**Subject: ITB #26071-B Justice Center Roof Replacement
Addendum #2**

FAYETTE COUNTY
JAIL EXPANSION
& CRIMINAL
JUSTICE CENTER

TITLE
**ROOF PLAN
& DETAILS**

A1.03

- MODIFIED BITUMEN ROOF OVER RIGID INSULATION
- MODIFIED BITUMEN ROOF OVER TAPERED INSULATION
- R.D. ROOF DRAIN
- O.F.D. OVERFLOW DRAIN
- D.S. DOWNSPOUT
- DRAINAGE ARROW

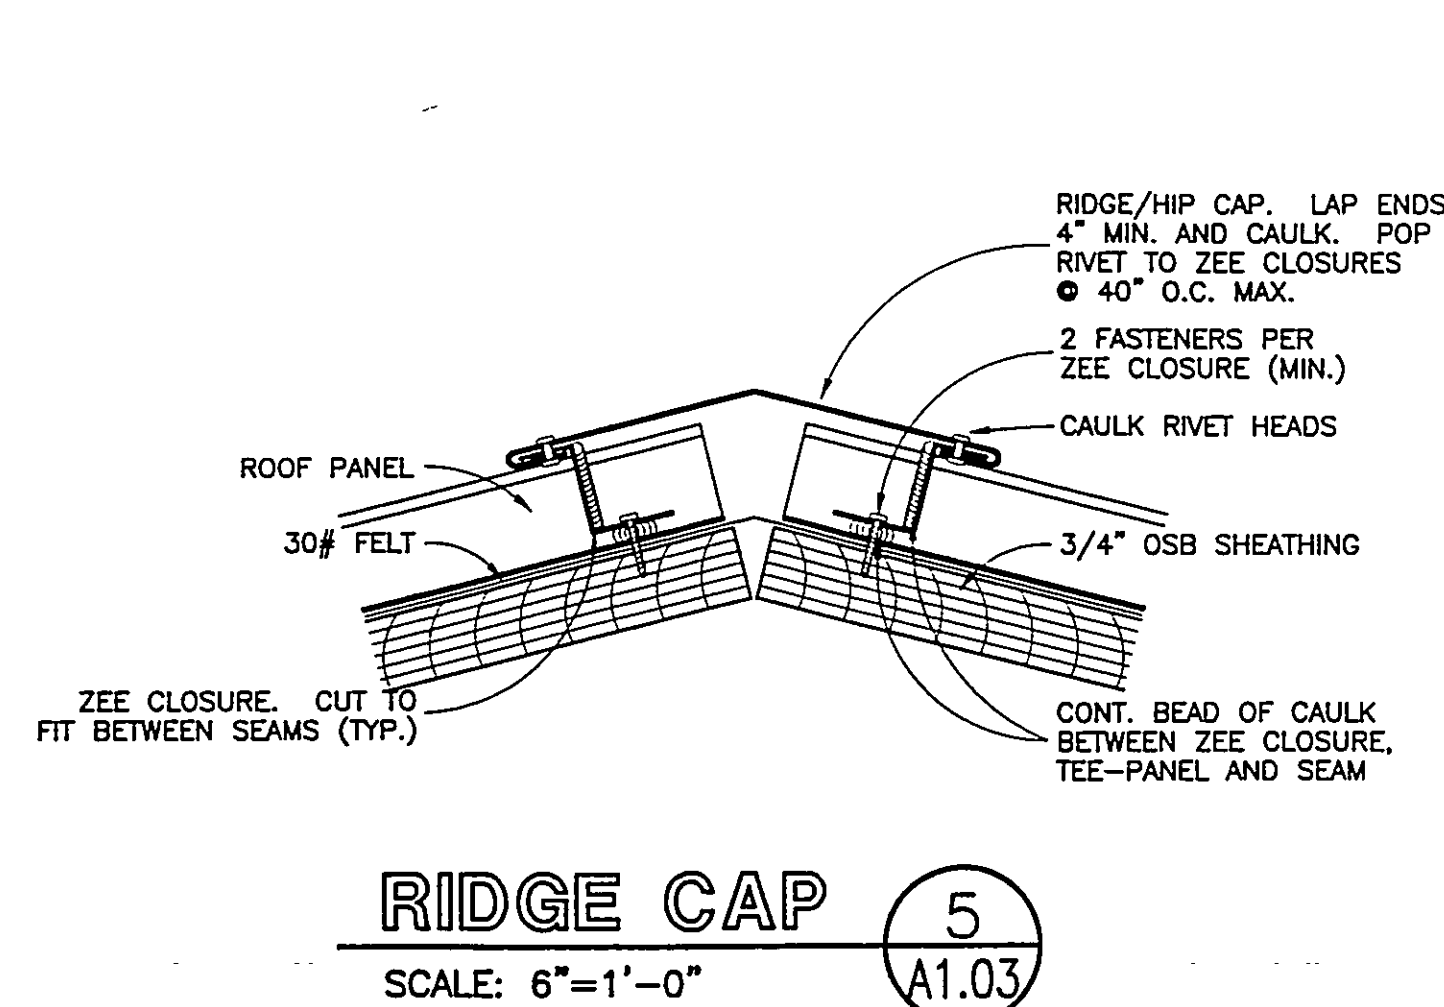
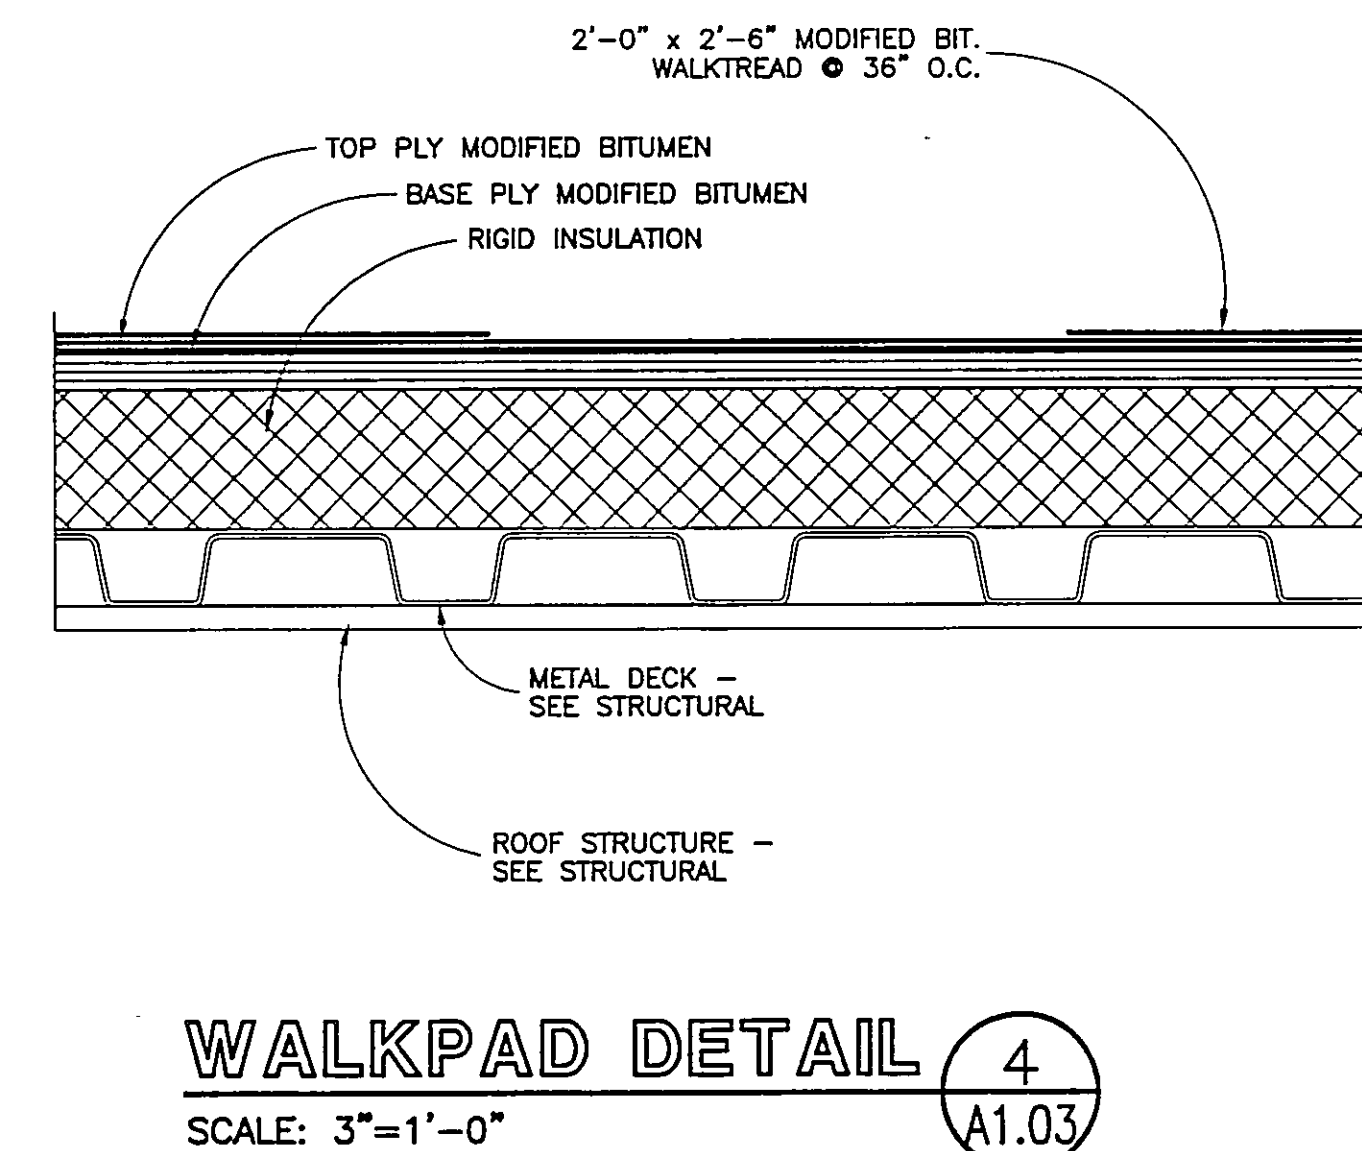
4. Are there any plans for the existing roof? **See Attachment 1.**
5. Will the contractor be responsible for the lightning rod removal and recertification after replacement? **Yes. Each bidder should include (In base Bid) the costs for a certified Lightning Protection installer to have the existing system removed and replaced upon roof completion and a certified Letter of findings upon completion.**
